STRATEGIC PLANNING COMMITTEE – 19th July 2023
ADDENDUM TO OFFICERS REPORT

Reference: 23/1082/FUL

Address: Barnet Elizabethans Rugby Football Club; Byng Road; Barnet; EN5 4NP

Light spill to northern tree line from floodlighting to pitch 1

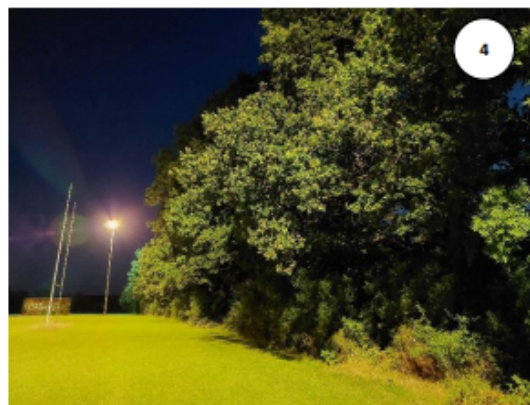
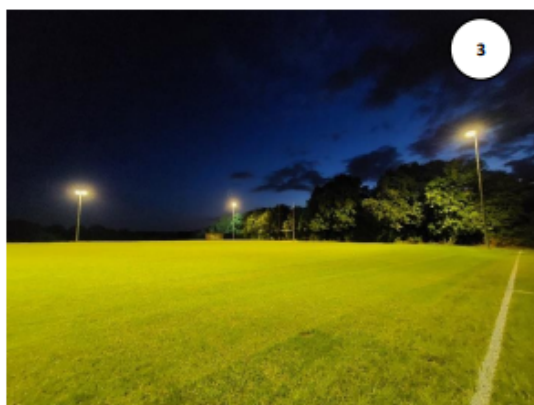
There remains a concern that relate to light spill penetrating the interior of the adjacent woodland and hedgerow at a low level (see below), however this could be effectively mitigated through the provision of a hedgerow around the perimeter of the field. The provision of a boundary hedge must be a condition of any approval granted to maximise the amount of shading that can be created for these sensitive ecological areas.

Existing lux level on site during night-time survey carried out by CPW at 22:30 on 12th July 2023.

To ensure all these mitigations have been effective the LPA would seek to secure appropriate post development bat activity monitoring to determine the effect of the final external lighting post development to be compared to the baseline the findings of which will inform any modification to the lighting mitigation measures as appropriate.
